**HISTORIC PRESERVATION COMMISSION
WORK SESSION
AUGUST 12, 2020
ASSEMBLY HALL
395 MAGNOLIA ROAD
PINEHURST, NORTH CAROLINA
11:30 AM**

PLANNING AND INSPECTIONS DEPARTMENT STAFF REPORT

To: Historic Preservation Commission
From: Peter Hughes, Senior Planner
CC: Darryn Burich, Planning and Inspections Director
Kelly Brown, Administrative Specialist
Date: August 20, 2020
Subject: Major COA Request for 55 Shaw Road (COA-2020-00098)

To: Historic Preservation Commission
From: Peter Hughes, Senior Planner
CC: Darryn Burich, Planning and Inspections Director
Kelly Brown, Administrative Specialist
Date: August 20, 2020
Subject: Major COA Request for 41 Shaw Road (COA-2020-00099)

1 PROPOSED LANDSCAPE PLAN
L1 SCALE: 1/16"=1'-0"

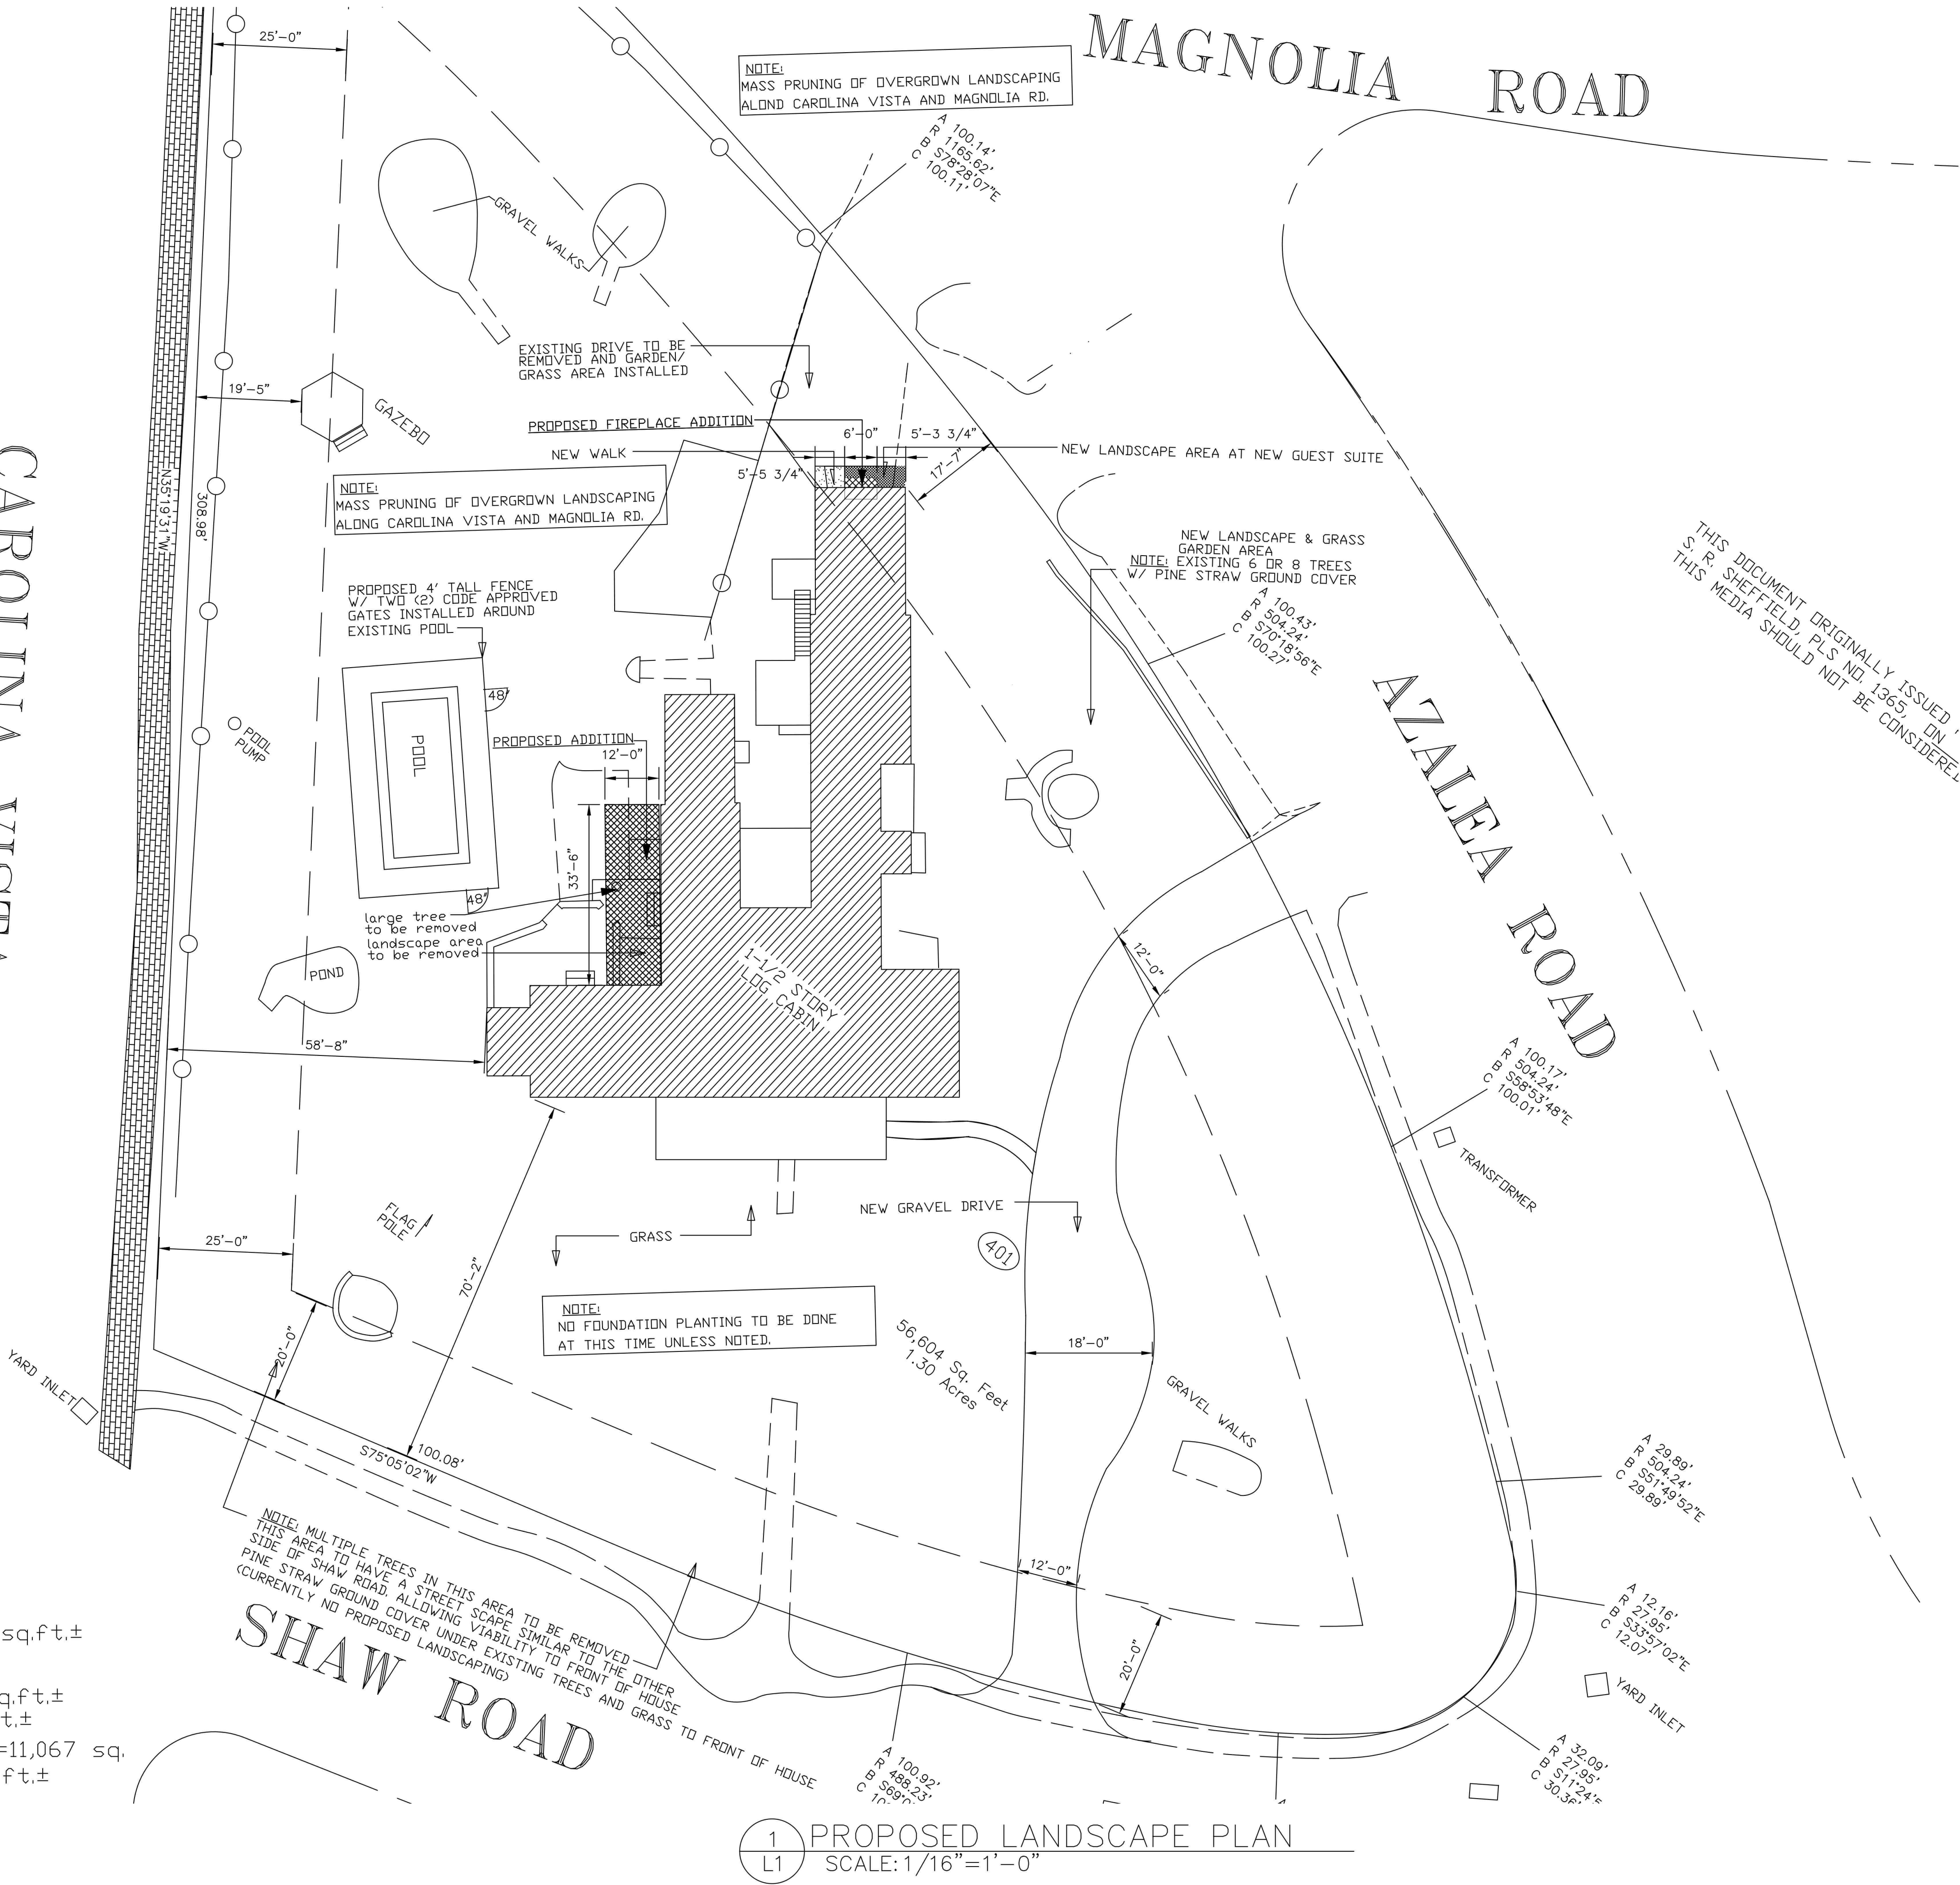
It is unclear from the submitted material whether existing large trees were incorporated into the plans for the addition and driveway reconfiguration.

2 PROPOSED LEFT ELEVATION
A2 SCALE: 3/16"=1'-0"

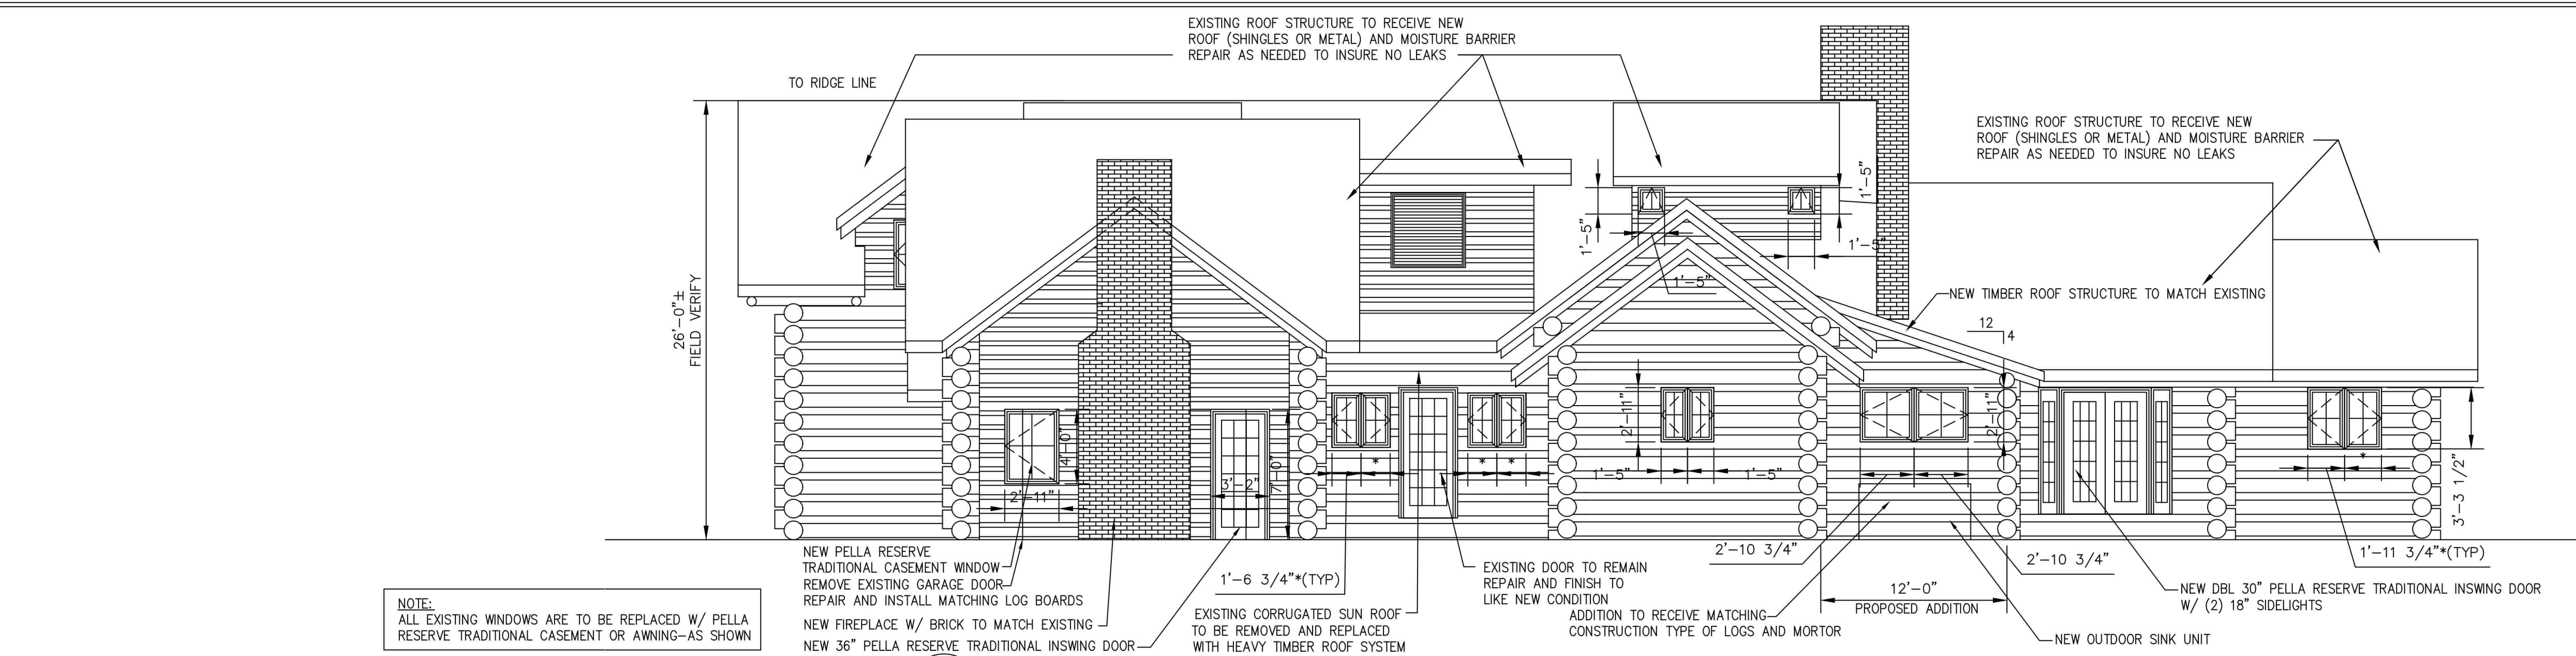
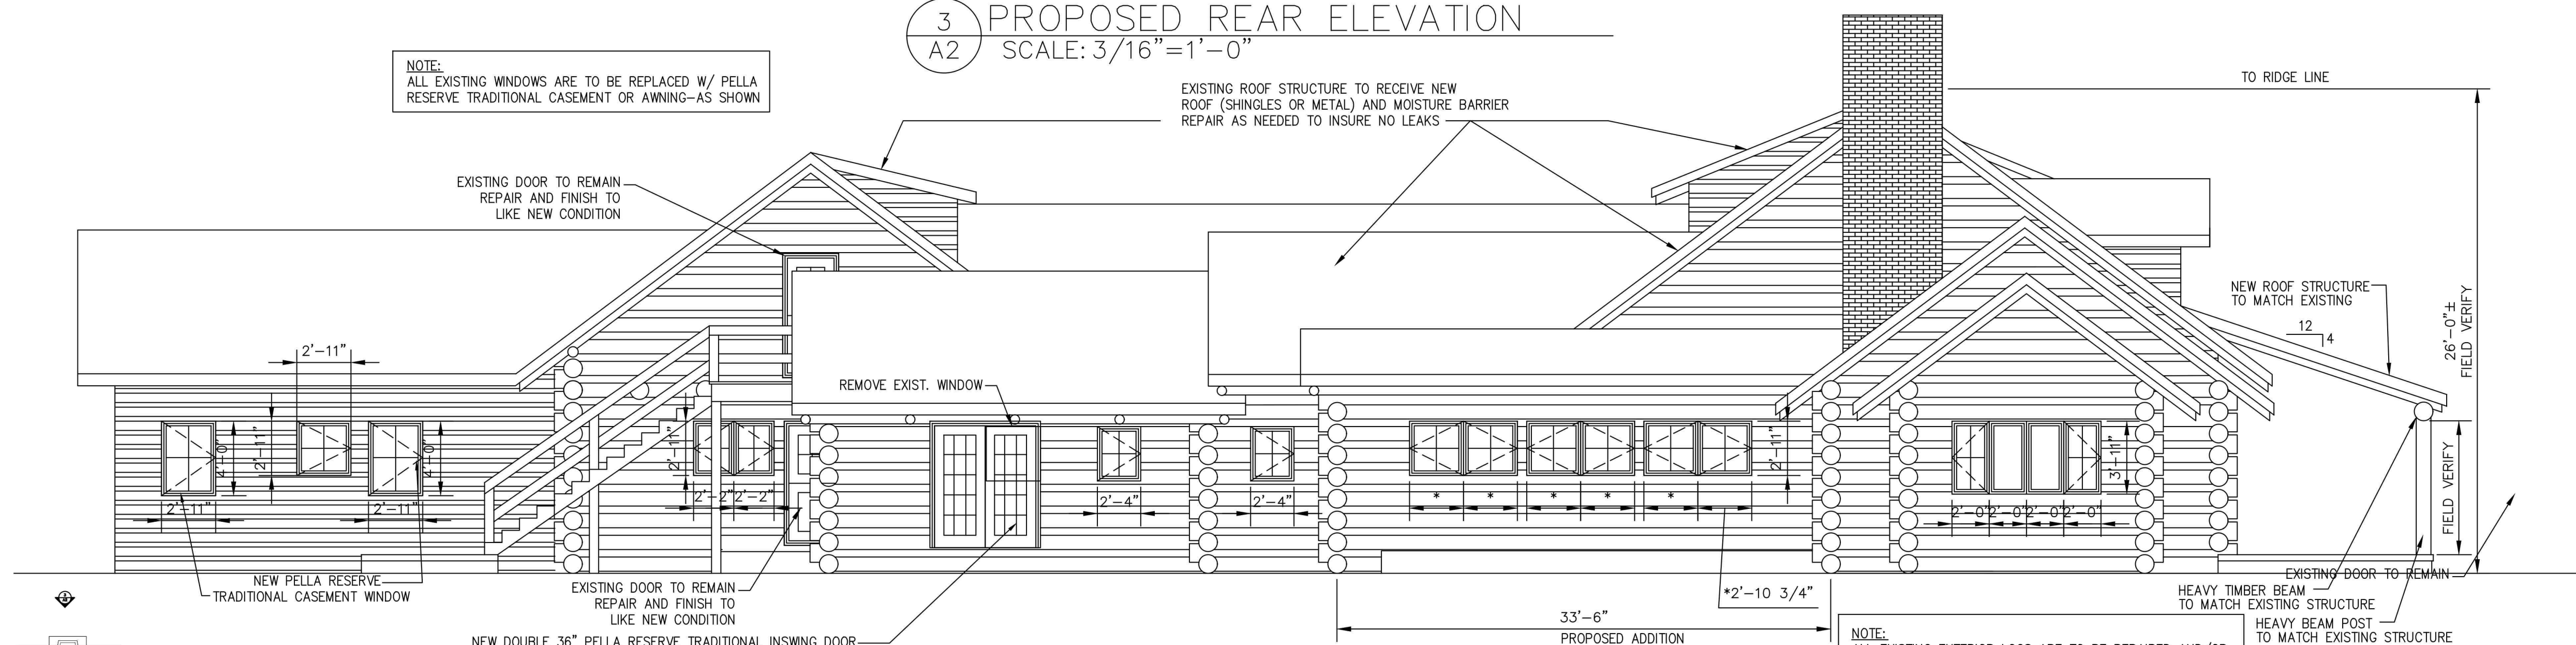
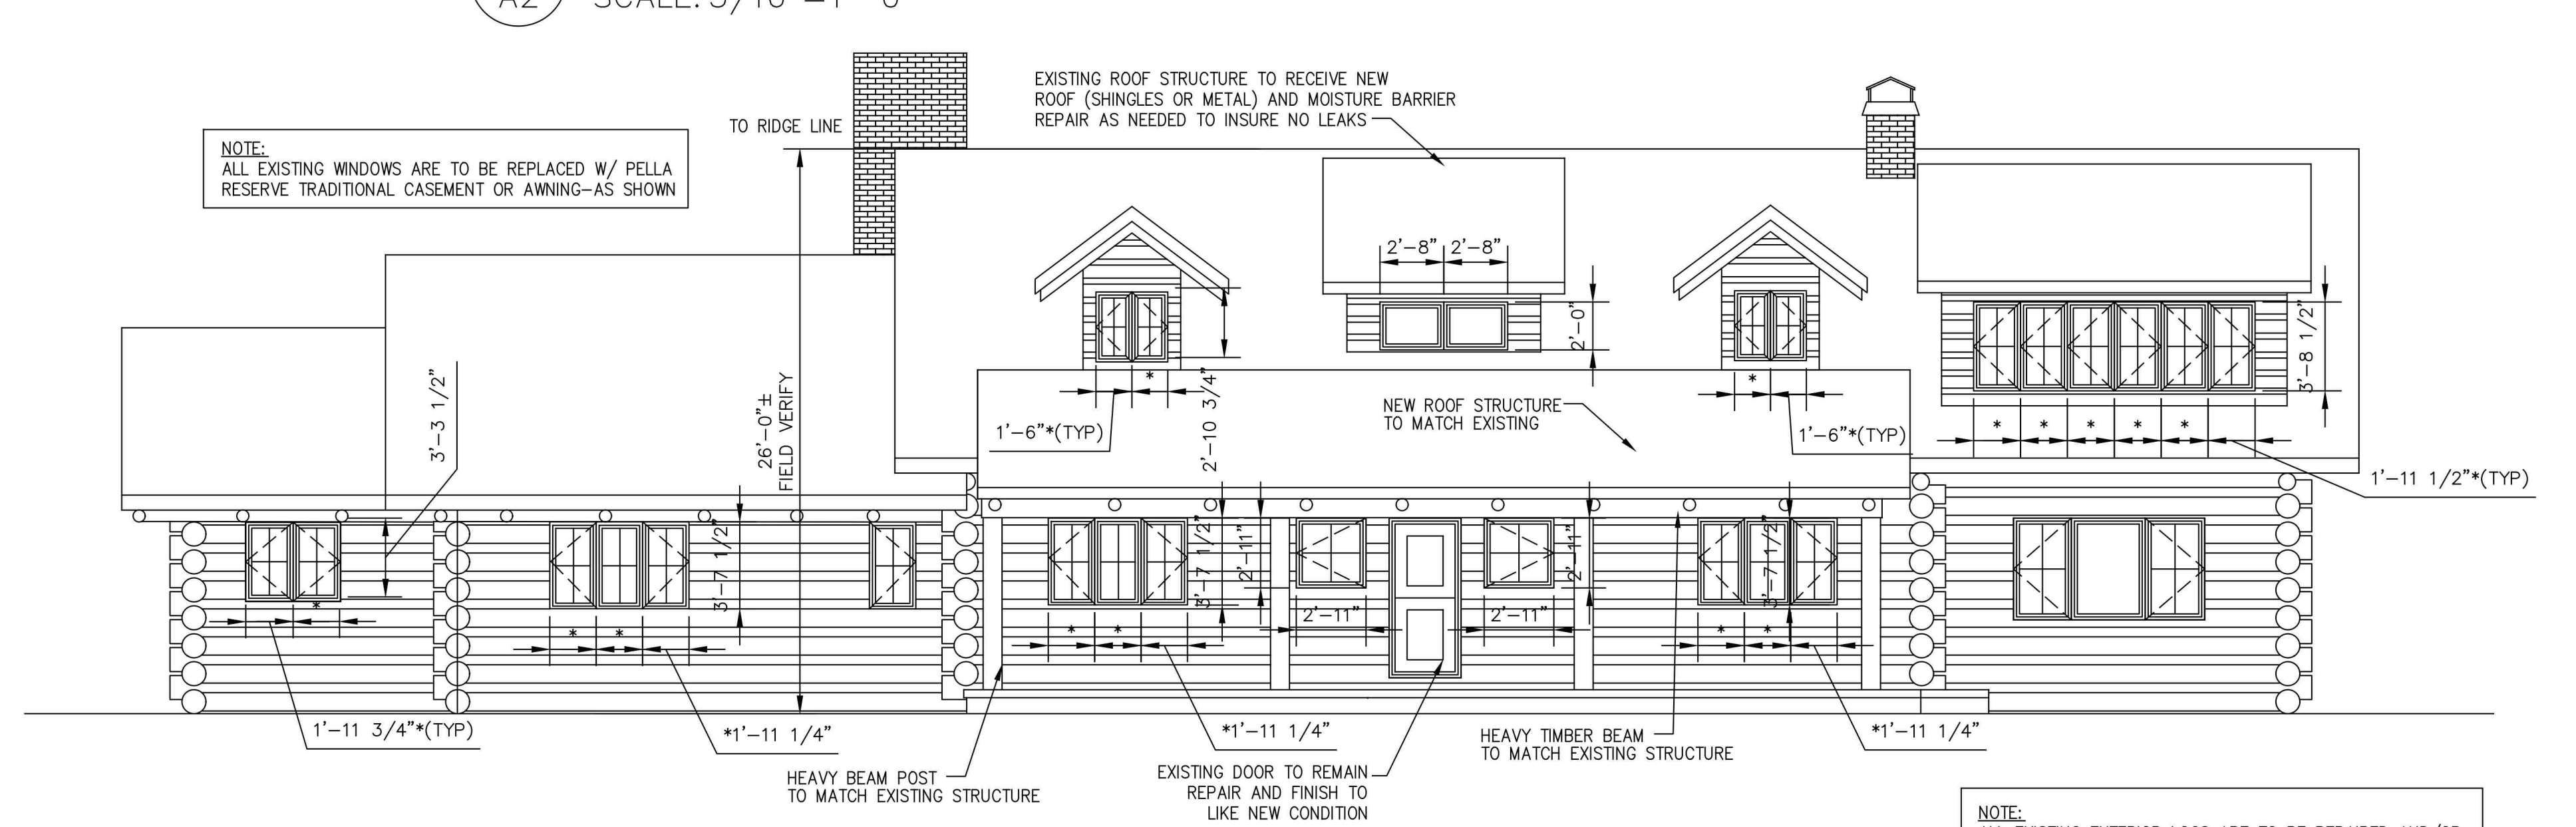
One window opening is proposed to be modified from a window to a door on the left elevation. The proposed door is compatible with other doors on the primary structure and the proposed modification should not compromise the architectural character of the structure.

A 400 square foot addition on the left elevation is proposed to accommodate an expansion and interior remodel. The proposed addition's building footprint, will require the removal of one mature tree, as noted on the site plan.
